Development Application DA2022/1675
Addendum Statement of Environmental Effects
Alterations and additions to a dwelling house including a swimming pool 57 Cutler Road, Clontarf

Reference is made to a number of issues raised by Council's Development Determination Panel (DDP) in its consideration of the subject development application during today's panel meeting. In this regard, this submission provides additional commentary in relation to the following matters:

Figure 1 - Plan extract showing 2 single flights of stairs within the proposed building

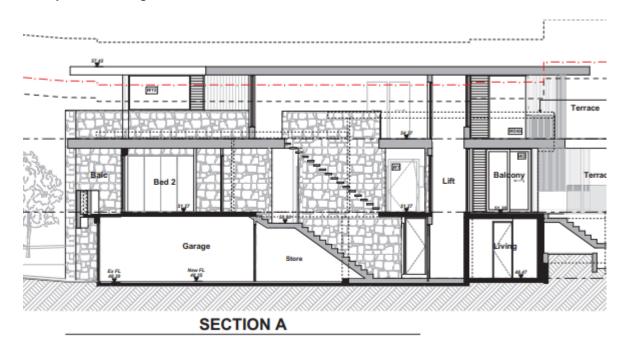
Confirmation that the internal stairs were appropriately included in the calculation of GFA/FSR

Section A on Plan A07(B) demonstrates that there are only 2 single flights of stairs within the proposed development an extract of which is over page. We confirm that the stair leading from the lower ground floor plan to the ground floor plan has been included in the GFA calculation with the stair between the ground floor and first floor additions excluded. This is consistent with the most recent case law where every second flight of stairs is counted as GFA.
